LOT 10 PARKER POINTE

LOT 10, PARKER POINTE FILING NO. 1
 A PART SECTION 3, TOWNSHIP 7 SOUTH, RANGE 66 WEST OF THE SIXTH PRINCIPAL MERIDIAN
 TOWN OF PARKER, COUNTY OF DOUGLAS, STATE OF COLORADO

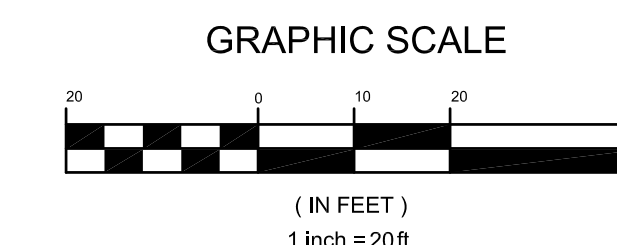
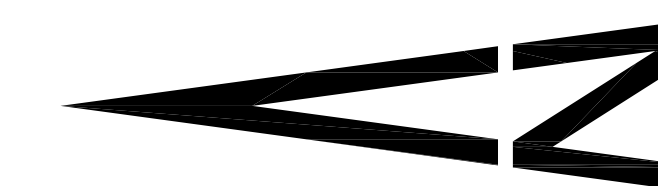
The relocation of HC parking has increased the access issue noted in the initial review comments. A clear walkway of a minimum of 7 feet must be provided. A ramp that leads directly into a patio area that will contain furniture is not accessible.
